ADDENDUM NUMBER 2 – JULY 22, 2024

AUGUSTA REGIONAL LANDFILL – LFGCCS EXPANSION

SOLID WASTE PERMIT NO. 21 AND NO. 585

Prospective Bidders are hereby advised of the following revisions to the Bid Documents for the subject Project:

| SHEET TITLE | STORMWATER CULVERT 1 |

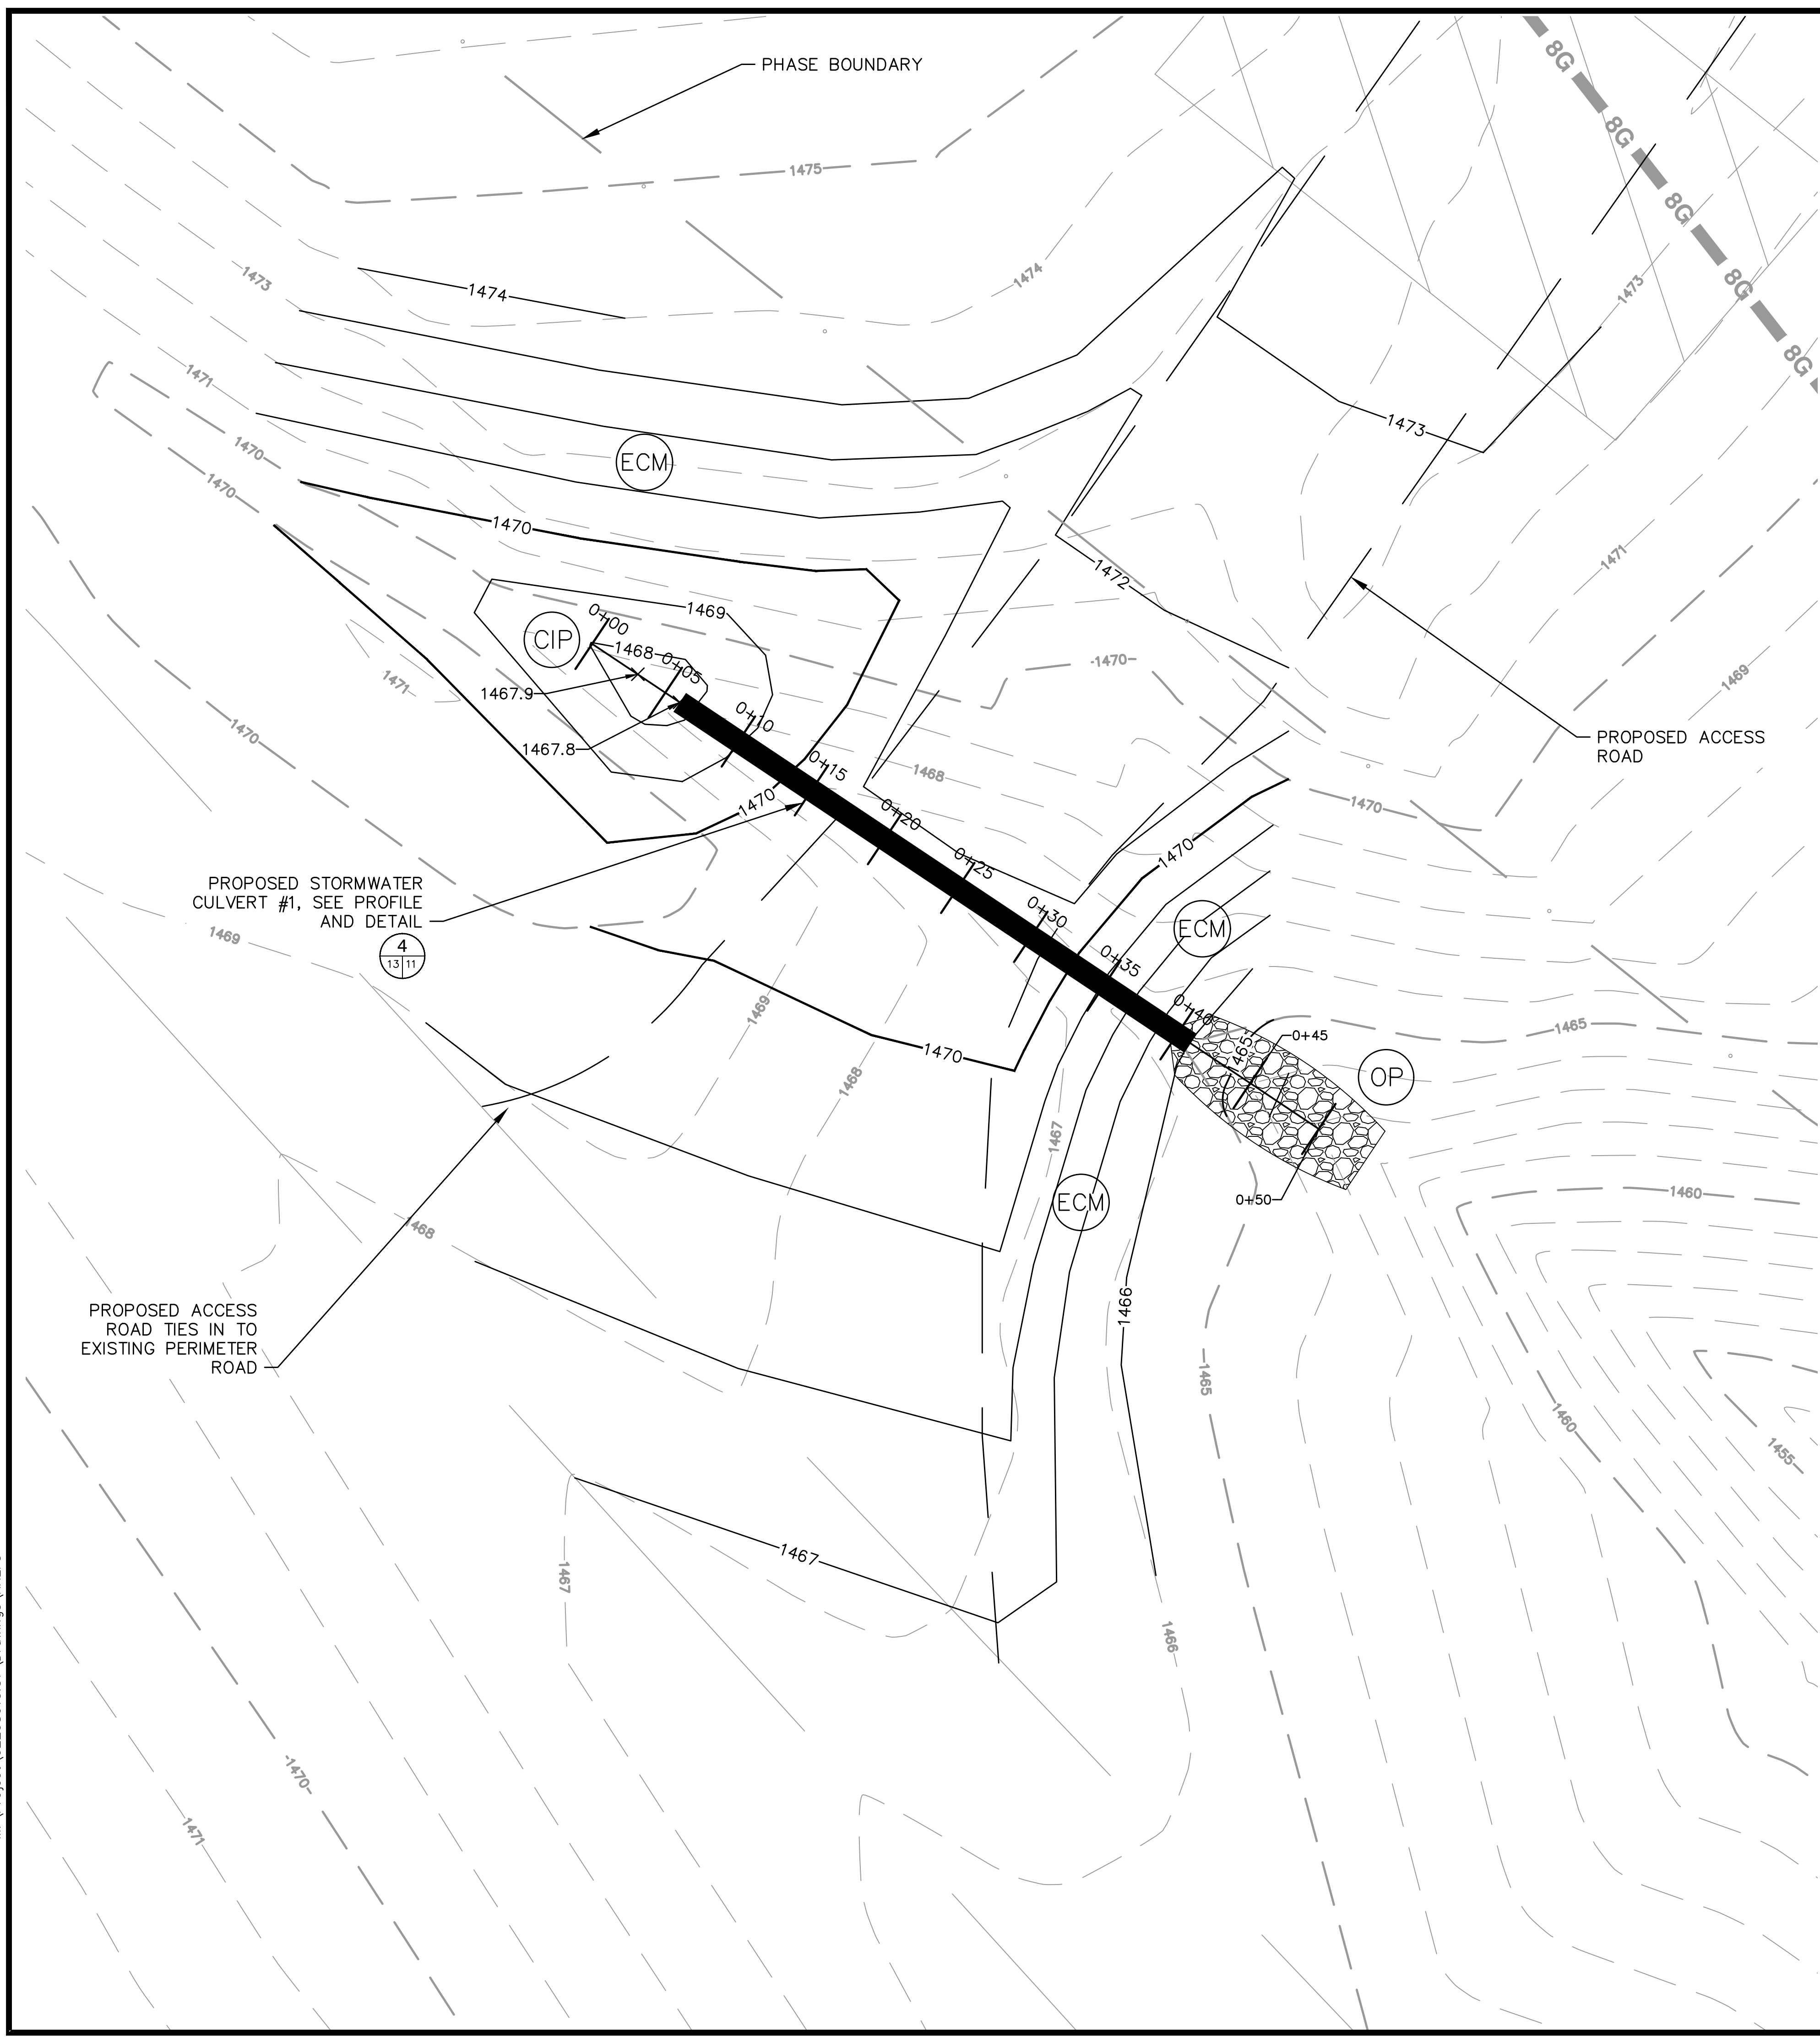
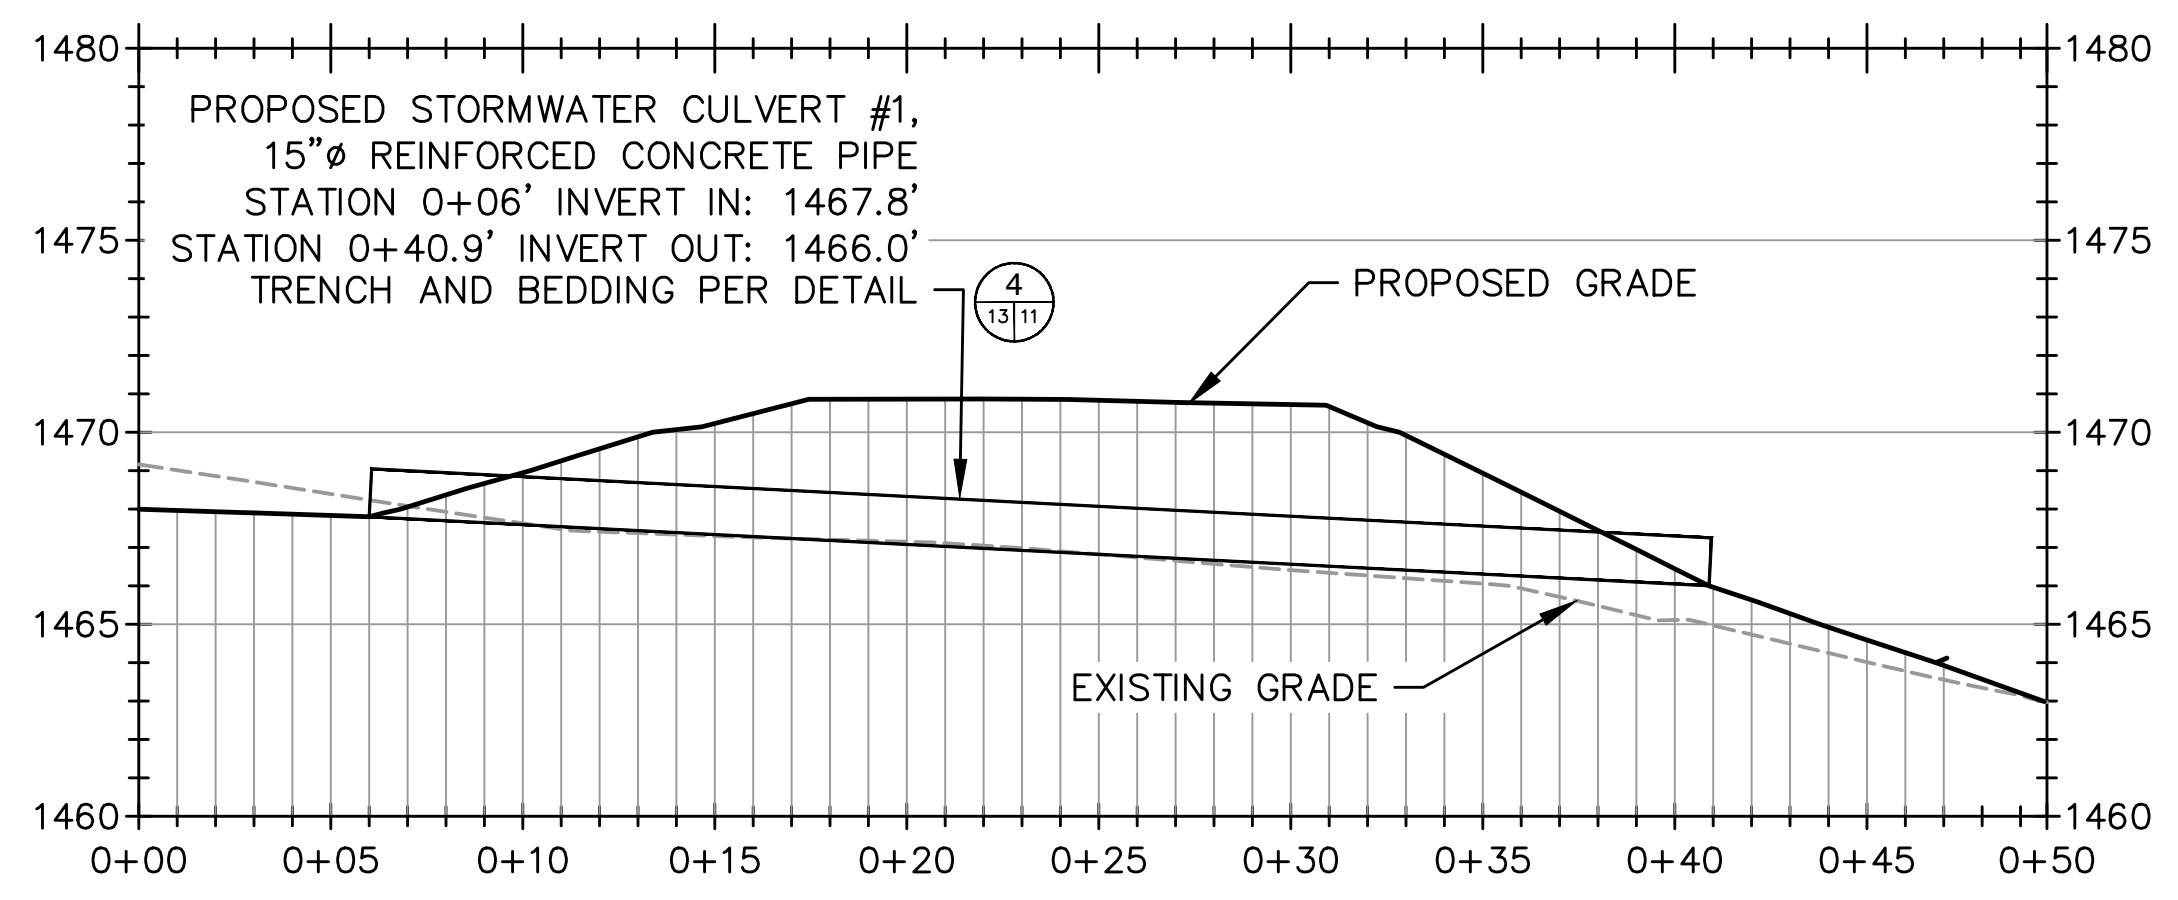
Question 9: Can profiles of the stormwater culverts be provided?

Answer: Profiles of the stormwater culverts have been added to new Sheet No. 13 and new Sheet No. 14.
